WILLIAMSON COUNTY, TEXAS

CHANGE ORDER NUMBER: 3

Project:	<u>1809-259</u>
Roadway:	<u>Lakeline Right Turn Lane</u>
CSJ Number:

**Lakeline Right Turn Lane
Williamson County Project No. 1809-259**

2851 1/2 S. LAKELINE BLVD.
LAKELINE TURN LANE
**PROPOSED SIGNAL LAYOUT -
LAKELINE/ HEB DRIVEWAY**

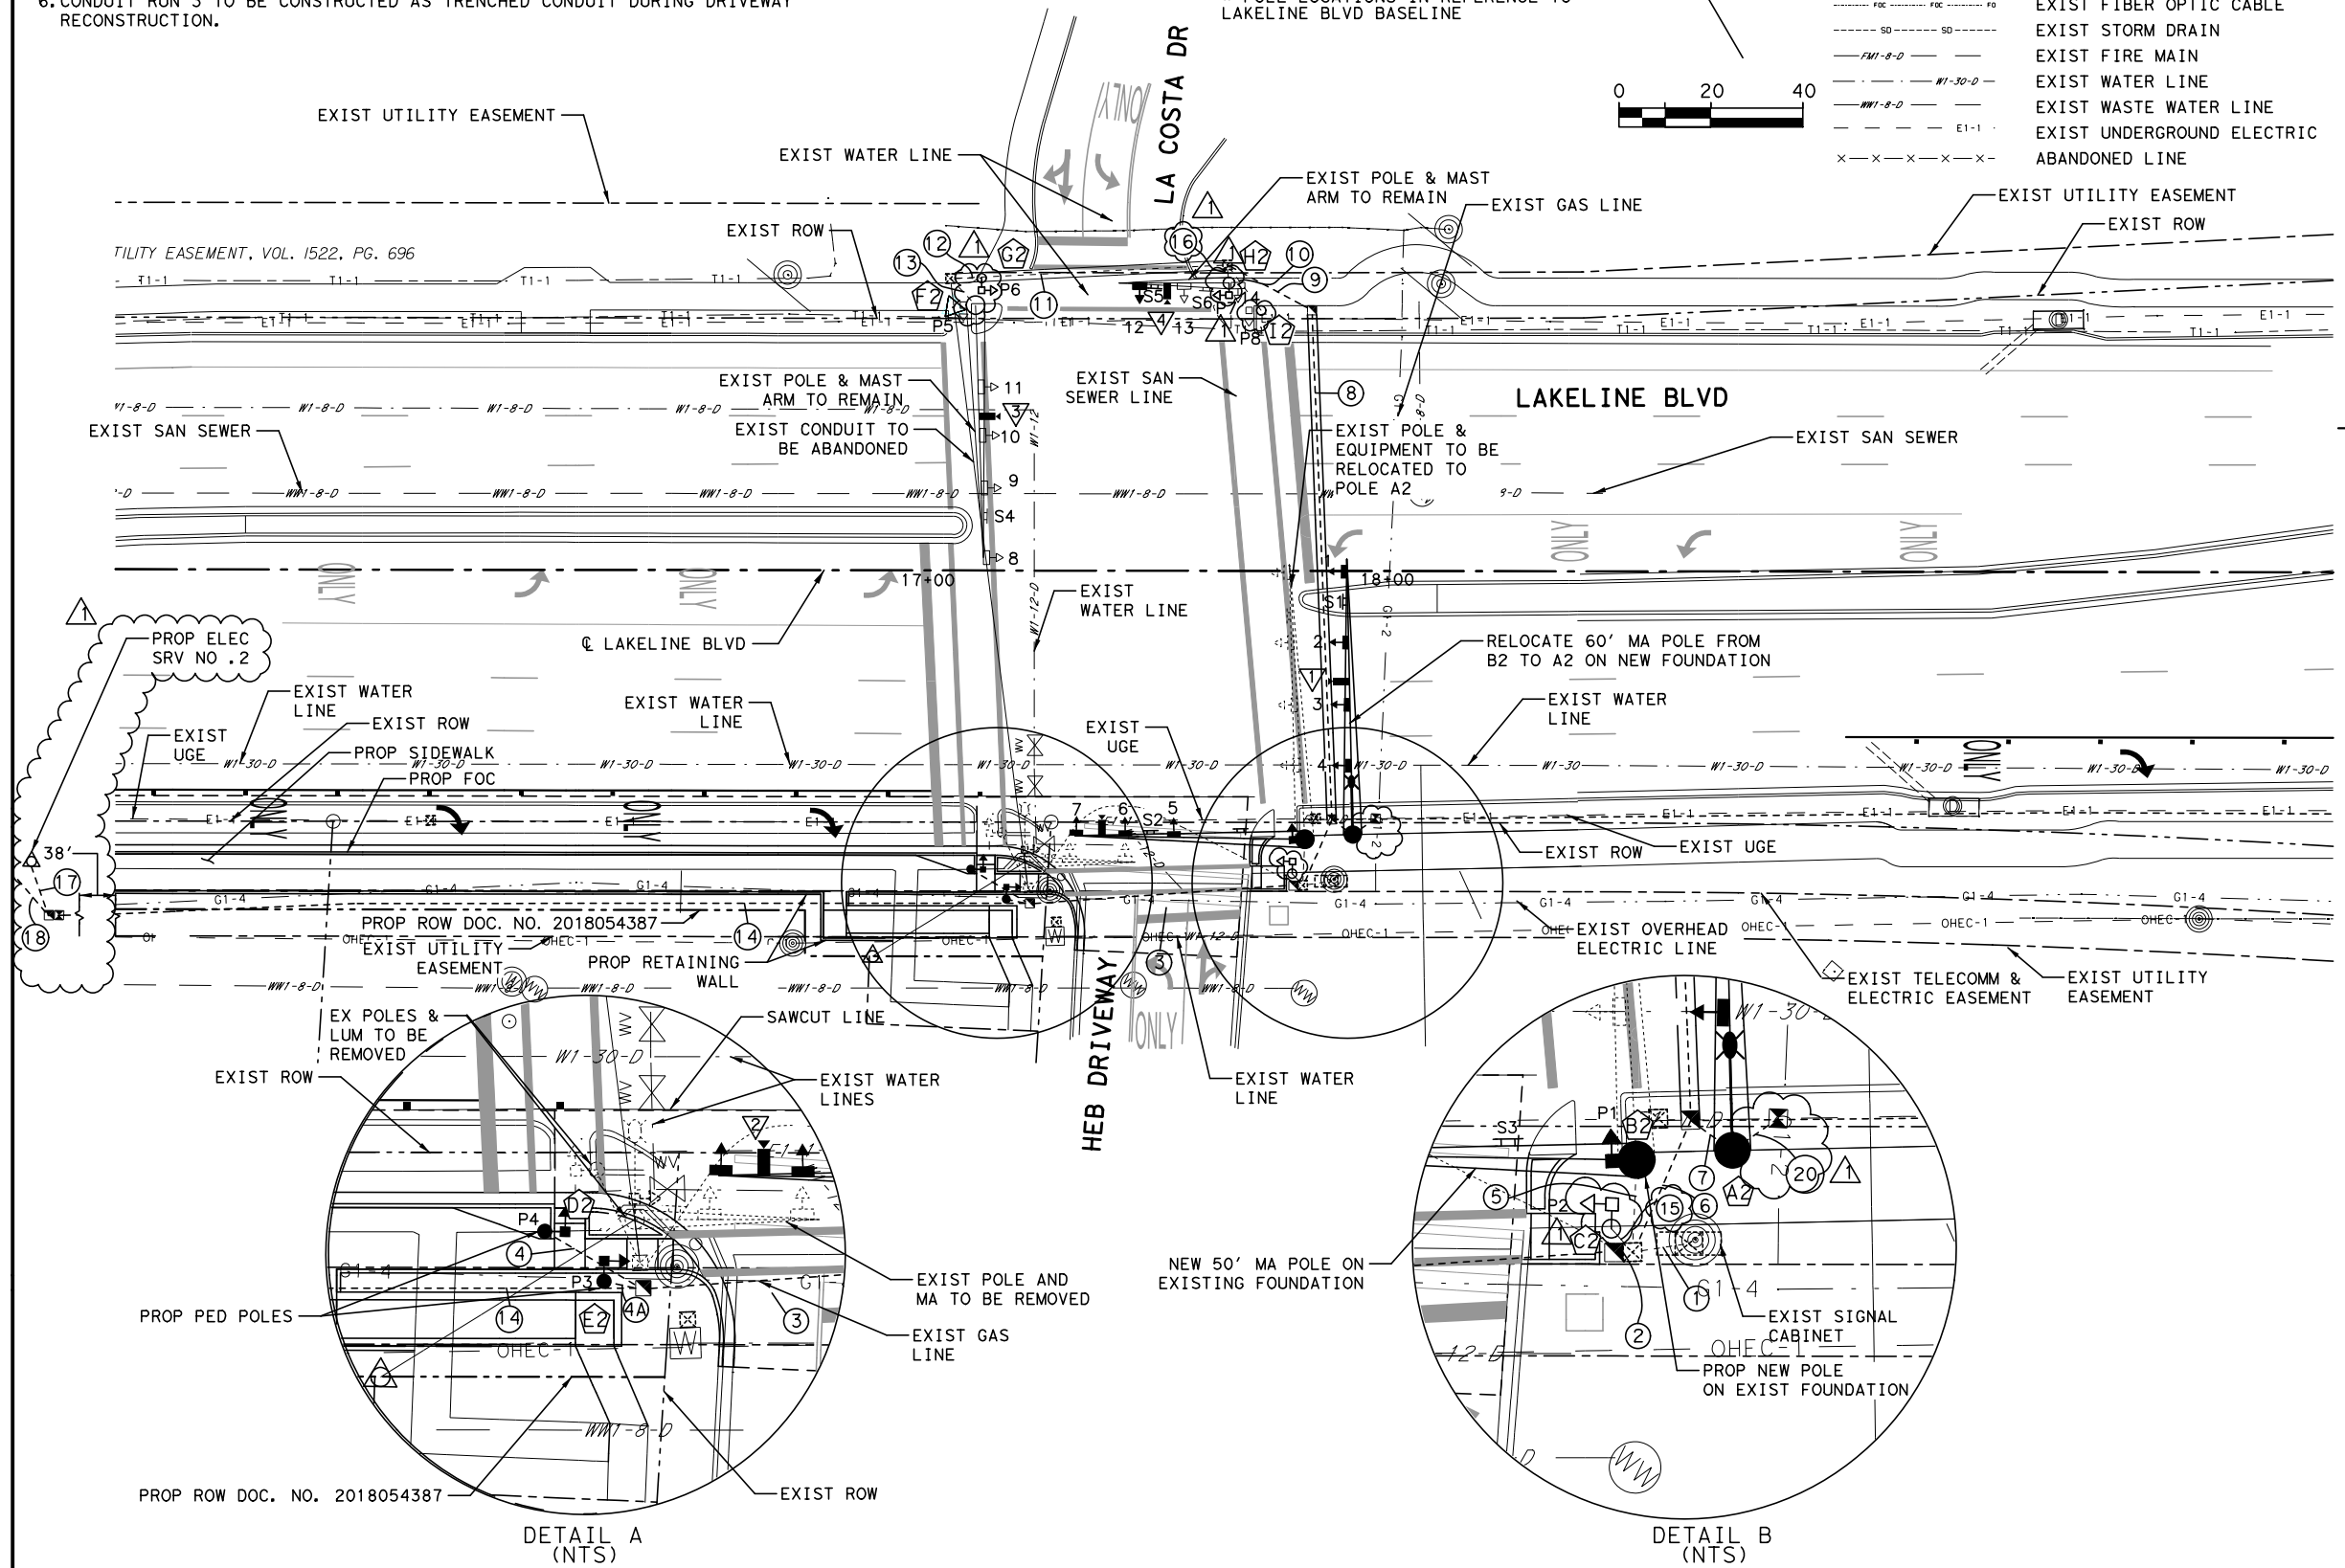
2. On the revised sheet 27, it is not clear what has actually changed. Since the wiring has changed, it is assumed that just the area of change has been bubbled. True? If not, please add call-outs to clarify changes. **Only changes were to ped head status as existing or proposed, conduit run numbers beyond run no. 14. Revision bubbles have been revised to be smaller / around the specific changes to clarify.**

3/5/19 PED SIGNAL/ILLUMINATION REVISIONS

2851 1/2 S. LAKELINE BLVD.
LAKELINE TURN LANE
SIGNAL ELEVATION -
LAKELINE/ HEB DRIVEWAY

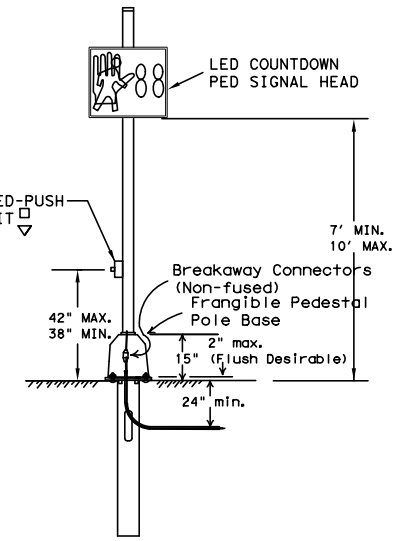
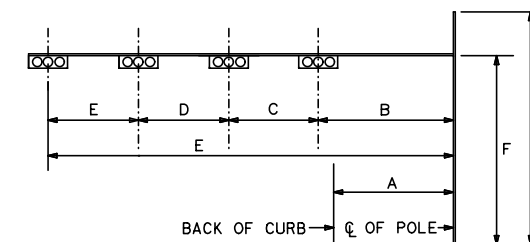
3. On revised sheet 28, it appears that only the call-outs have been updated to say which Ped signals are existing. Correct? **Correct – this is to clarify that these are to remain. Revised to state “Existing to Remain” in callouts to be more clear.**

2851 1/2 S. LAKELINE BLVD.
LAKELINE TURN LANE
ILLUMINATION LAYOUT

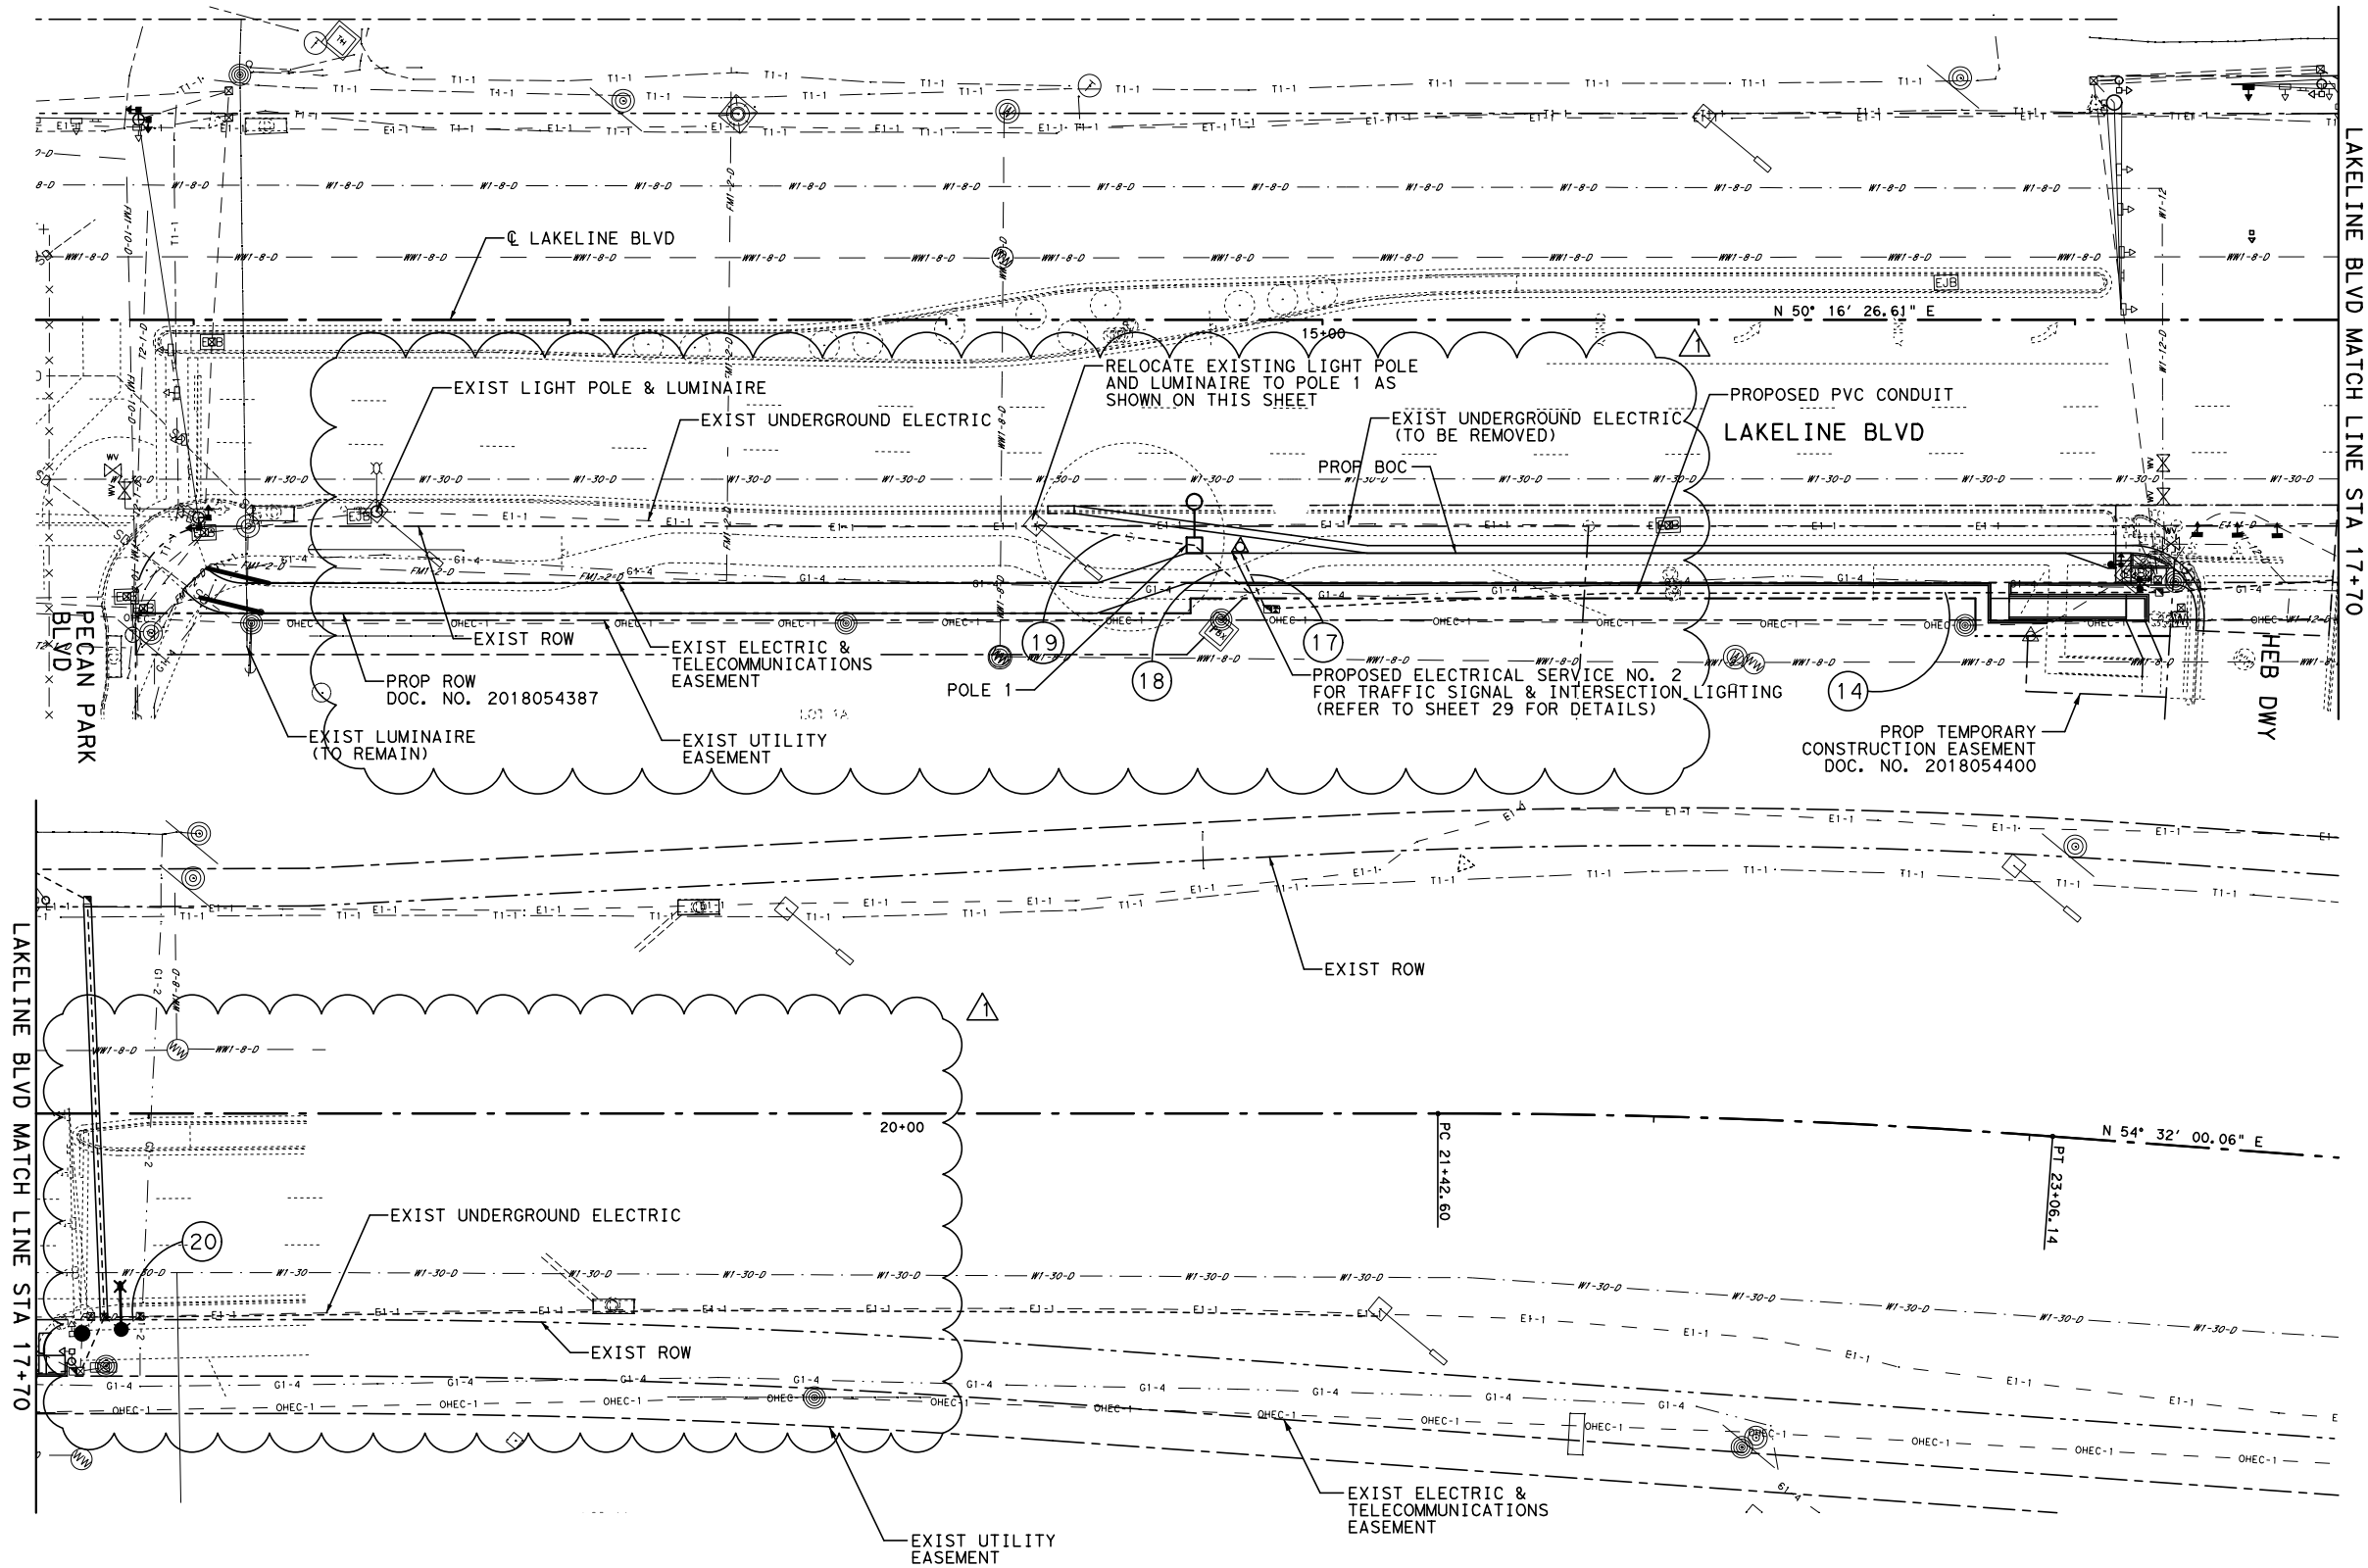
5. Revised sheet 31 has several quantity differences from the original plans that are not bubbled. Please update sheet and also provide a list of item numbers that have changed with their deltas. This will be used to create a draft Change Order. **Sheet updated and items with deltas provided in PDF attached.**
6. Since revised sheet 34 has poles and services, please update sheet table that shows stations and offsets for placement purposes. The revised sheet still shows the same numbers in the table as the original sheet, but the location has changed. **Previous sheet only showed roadway illumination Pole 1 station and offset (location unchanged from bid set). Pole 1 is the only new location roadway illumination pole. Station and Offset for Electrical Service No. 2 on sheet 34 has been added as a new table to clarify location of service pole.**

We are working towards updating the sheet for illumination (34) and will also make some revisions to sheets 27-31 based on impacts to conduit / wiring charts and quantities tables. Because RFI #18 and RFI #19 are interrelated, we are going to submit both on Monday by COB with all the revised sheets to avoid confusion.

ELECTRICAL SERVICE LOCATION				
POLE	ALIGN	STATION	OFFSET	DIRECTION
2	LAKELINE	14+78.00	60'	RIGHT
